MASSACHUSETTS INSTITUTE OF TECHNOLOGY
DEPARTMENT OF MECHANICAL ENGINEERING
CAMBRIDGE, MASSACHUSETTS 02139

June 30, 1980

I am writing my impressions of the last advanced code review group meeting. I found it, it general, very worthwhile. Let me organize my impressions into four categories:

PROPOSED METHOD OF ANALYZING SMALL BREAKS

Zion Plant

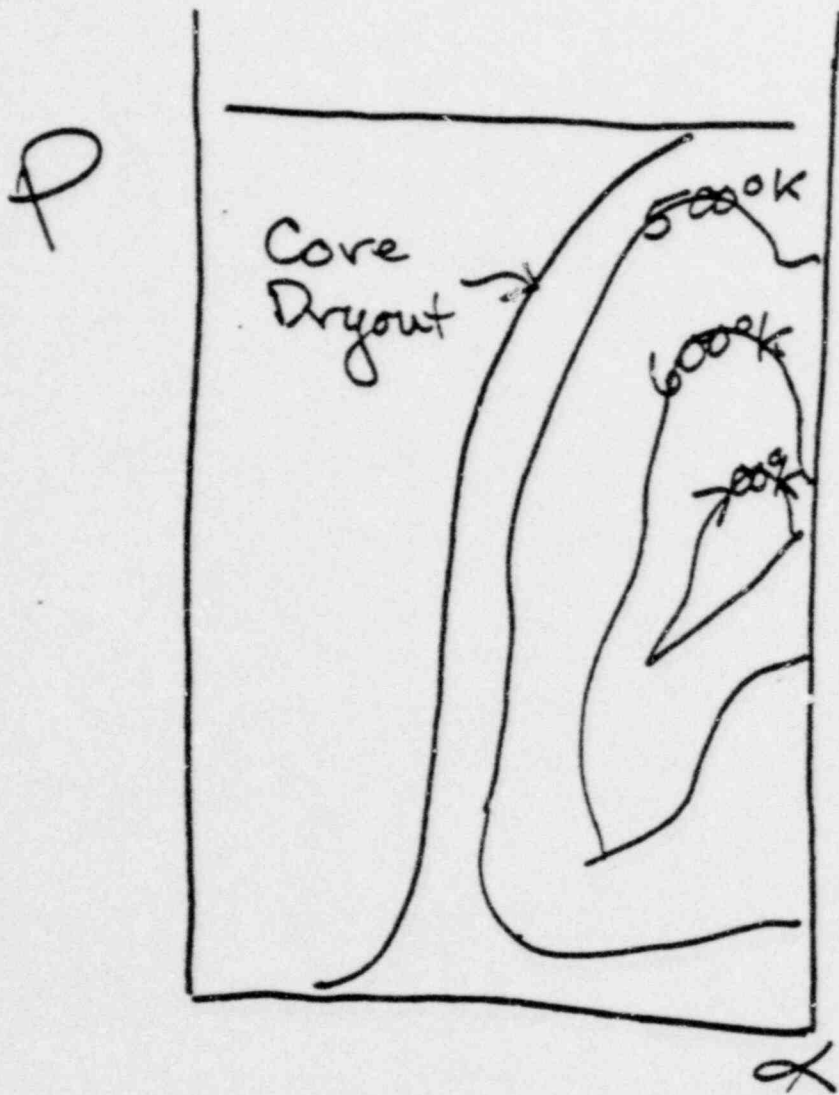
Let's calculate a map, much like the one enclosed for all conditions. Void fraction doesn't completely define the system, the void can be distributed in various ways. Assume it is distributed in the worst possible way for these calculations.

A single pretest prediction, consisting of a book of maps of this kind, would be made for a single loop. No matter what happened in any experiment a comparison of pre-test prediction to experiment could be made. Perhaps this map could show maximum core temperature as a series of lines in the dryout region. If this procedure is chosen, then a plot for each experiment could be made perhaps, a plot of $(T_{\max})_p$ predicted vs. $(T_{\max})_o$ observed for every state that the reactor passed through. The comparison would show a worm track of states to one side (hopefully) of the 45° line on the $(T_{\max})_p$ vs. $(T_{\max})_o$ plot. Look what this does for you on small breaks.
